01 July 1999 B-H200-16716-ASI

Subject: NTSB Recommendation A-99-27, Block Maneuvering Speeds-USAir 737-300 N513AU Accident near Pittsburgh, Pennsylvania-8 September 1999

Subject: MANEUVERING SPEEDS FOR 737-100/200/300/400/500

Reason: Revise the Boeing Recommended Maneuvering Speeds

- Boeing Figures 1-4, Block Speeds Flaps Up, 1, 5, 10
- (reference (c))
- cc: Mr. Tom Haueter, NTSB, AS-10

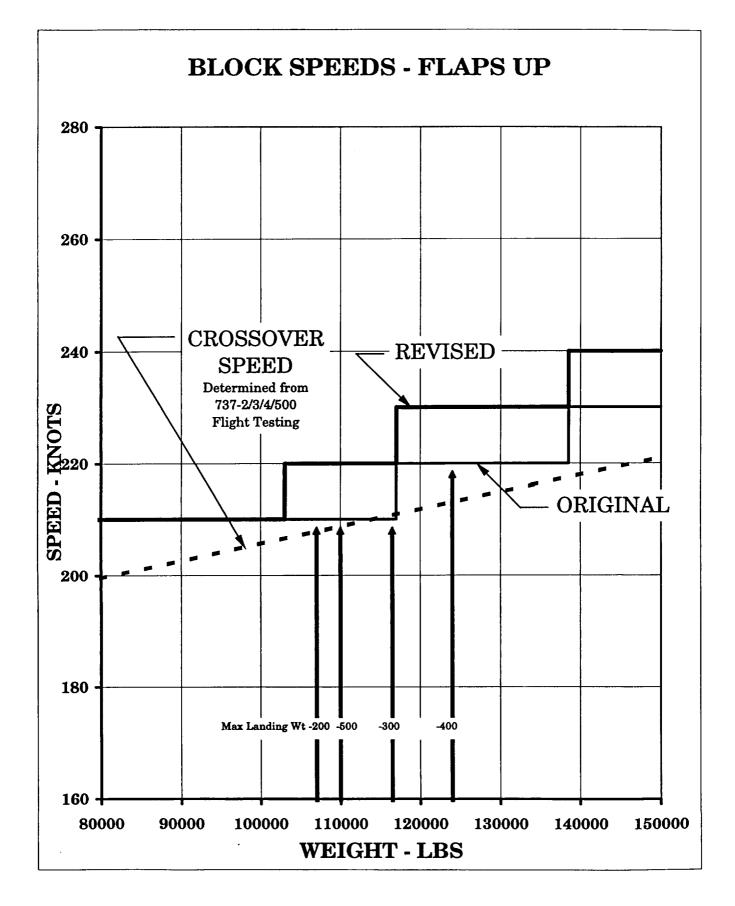
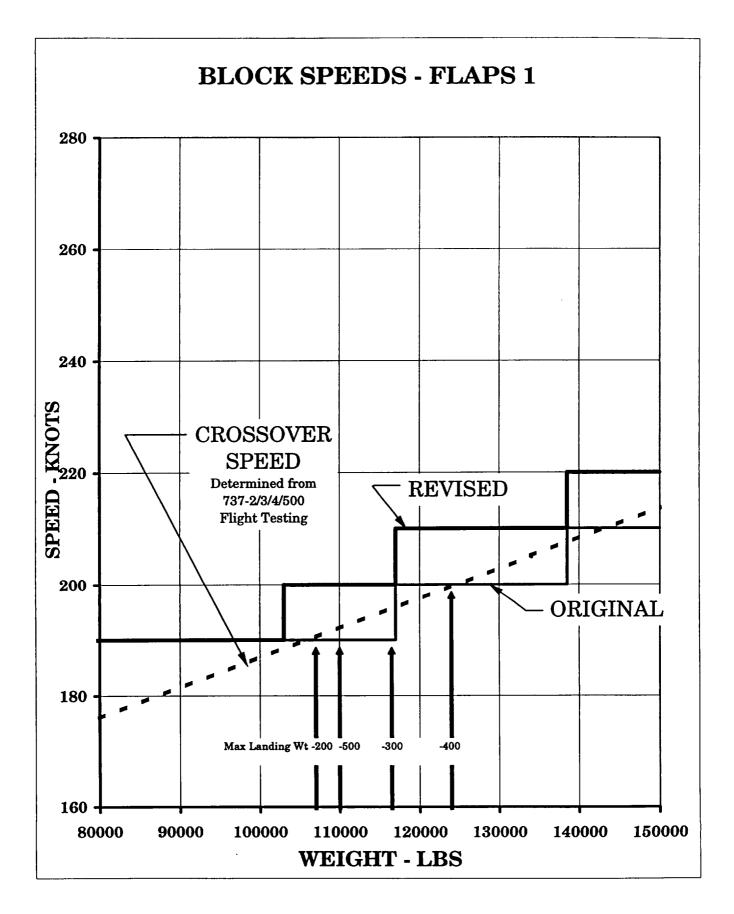
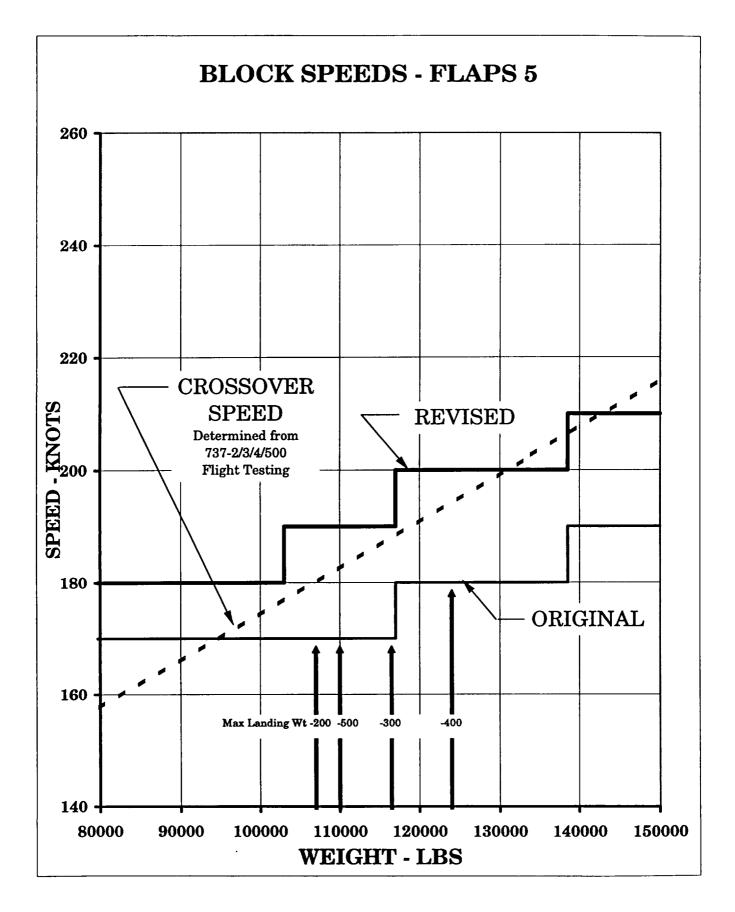
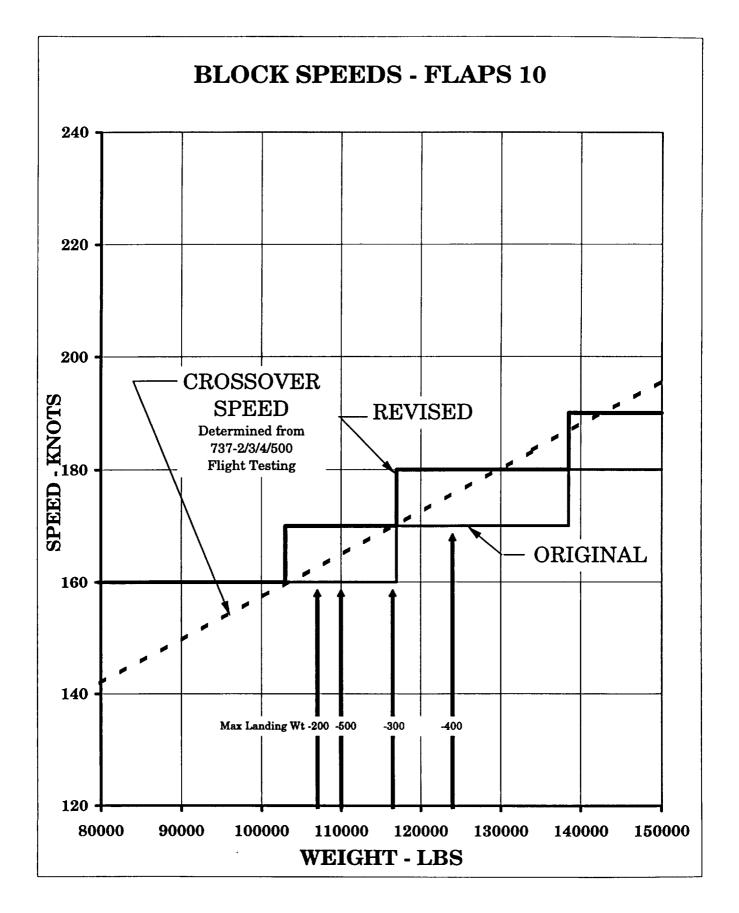
The original and revised recommended Block Speeds along with the crossover speeds are shown in figures 1-4 for flaps up through 10 respectively. Note that the revised Block Speeds are equal to or greater than the crossover speeds up to well beyond the maximum landing weight for any 737 model.

Boeing 737 maneuvering speeds have been adjusted to provide a margin to the flight test demonstrated speeds where the lateral control system can just balance the roll due to rudder sometimes called the "crossover speed". Figures are enclosed which show the crossover speeds and recommended maneuvering speeds (Block Speeds) as a function of weight for each flap setting where the Block Speeds were changed. The crossover speed data were determined using flight test data from the 737-200, 737-300, 737-400 and 737-500 models. Block Speeds were increased from 0 to 20 knots depending on weight and flap setting.
